Economic Commission for Europe

Informal Ad hoc Expert Group on Conceptual and Technical Aspects of Computerization of the TIR Procedure

Amendments to the eTIR conceptual, functional and technical documentation - v.4.2a

Note by the secretariat

Figure 1.48: (English only)

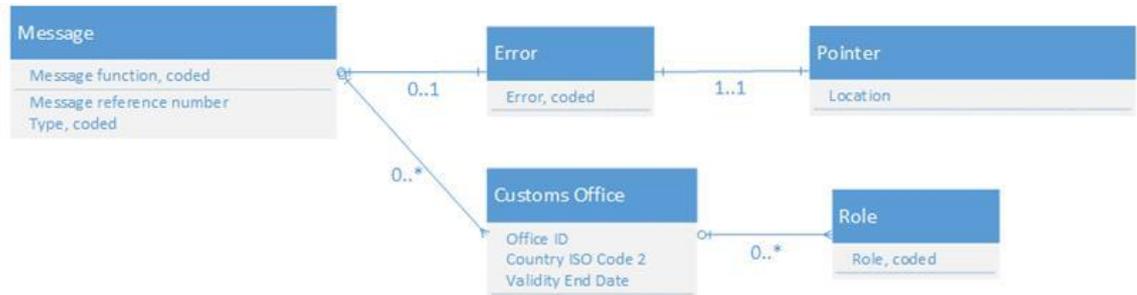
13. The Expert Group may wish to consider the draft interface proposed in Annex II. Furthermore, the Expert Group may wish to request the secretariat to make the necessary changes in Figure 10 of the eTIR concepts document to add a new “get customs info” use case connected to ITDB and introduce the necessary changes in the rest of Chapter 3.2.

Annex II Draft interface for the ITDB customs offices database

eTIR Class/Attribute Name	Occurrences
Message	..
Message function, coded	
Functional reference	
Message reference number	
Type, coded	
Error	0 .. 1
Error, coded	
Pointer	1 .. 1
Location	
Customs Offices	0 .. unbounded
Office ID	
Country ISO Code 2	
Validity End Date	
Role	0 .. unbounded
Role, coded
